©Kawasaki Motors Corp 1974 Printed in USA

PROBLEMS:

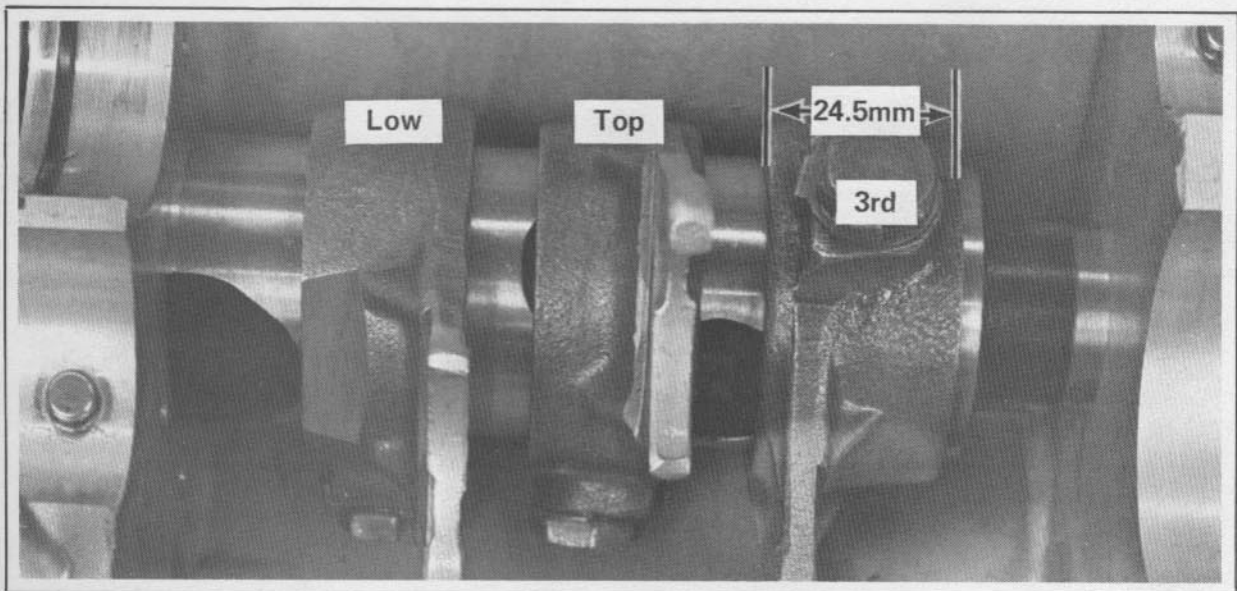
H1/H2 transmission problems have often included poor third gear engagement. This may be caused by two possible problems including the play of the fixed gears on the shafts and the lack of positive action in the third gear shift fork.

The second problem has been countermeasured by widening the base of the shift fork to keep the fork more rigid on the shift drum. This wider fork is supported on both sides of the groove on the shift drum.

The new fork is easily recognized by its wide base.

DESCRIPTION	OLD PARTS		NEW PARTS		INTER-CHANGE	EFFECTIVE I.D.
	P/N	REMARKS	P/N	REMARKS	OLD↔NEW	
3rd gear shift fork H1	13140-013	21.0mm wide	13140-064	24.5mm wide		KAE-87023
3rd gear shift fork H2	13140-048	21.0mm wide	13140-065	24.5mm wide		H2E-31941
